Service Bulletin: UL Series (UL25; UL32; UL40)

Reference: SBU10.01

### Affected Machines: **UL Series 220V AC** Serial Numbers: 31089 - 31407

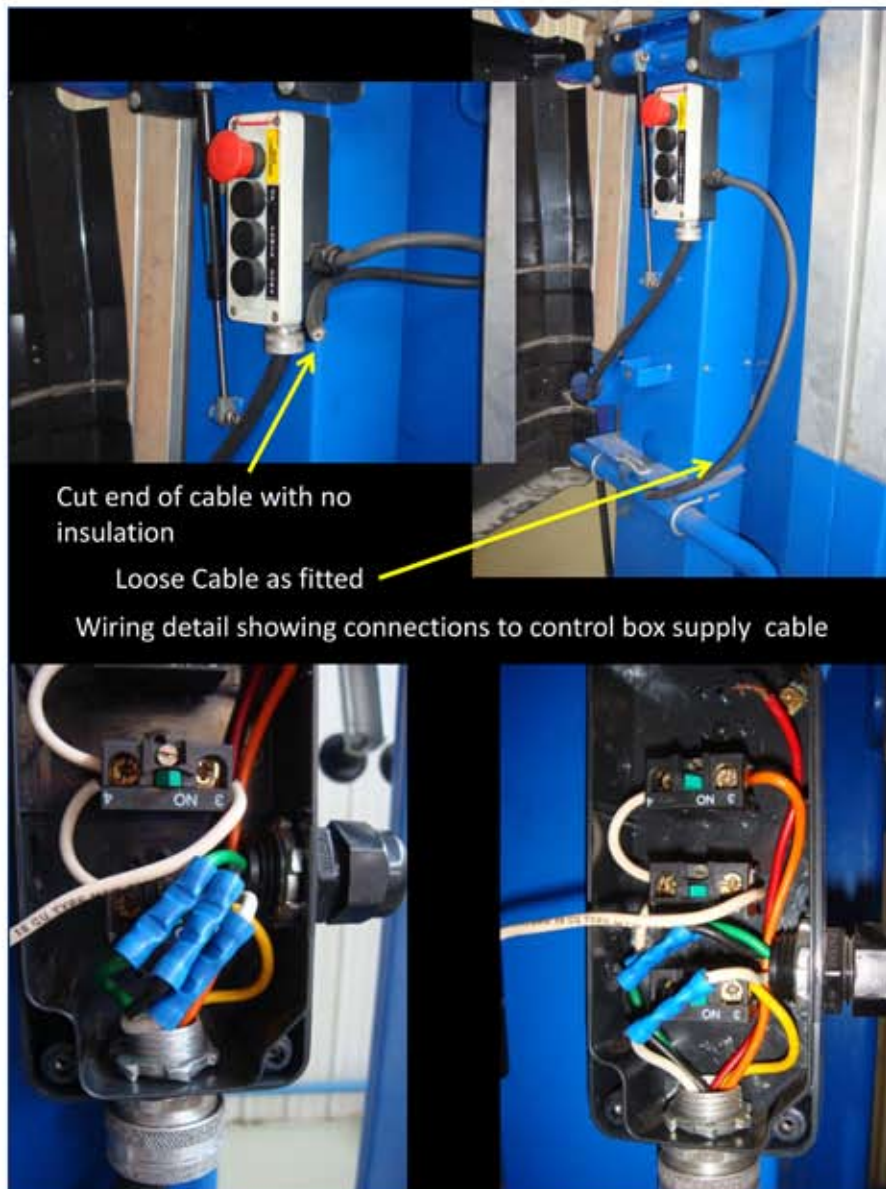
The power to platform option is provided by a 'flying lead' which has one end terminated in the platform control box (photographs below). The other end of the lead is provided as a customer option which can be terminated using an electrical socket which is appropriate for the region in which the machine is being used.

However when the machine is delivered the unused end of the cable should be protected with insulation to ensure that the cut ends of the cable are not exposed.

We have found examples where the user end of the cable has not been terminated or insulated resulting in the cut ends of the cable being electrically 'live', with the potential for an electrical shock hazard.

- 1) Ensure that the machine is switched off and disconnected from any electrical power source.
- 2) Confirm whether the power to platform flying lead has already been terminated to an electrical power socket (by customer option)
- 3) Unless an electrical power socket has already been fitted to the power to platform flying lead then one of the following options should be implemented by a suitably qualified technician to rectify this issue.
  - a. Terminate the flying lead using an approved electrical power socket which is appropriate to the region in which the machine is being used.
  - b. Disconnect and remove the flying lead by removing the terminations of the lead from the blue in line crimped connectors inside the control box (see pictures). It is then most important to ensure that the cable connections remaining in the control box are fully insulated.
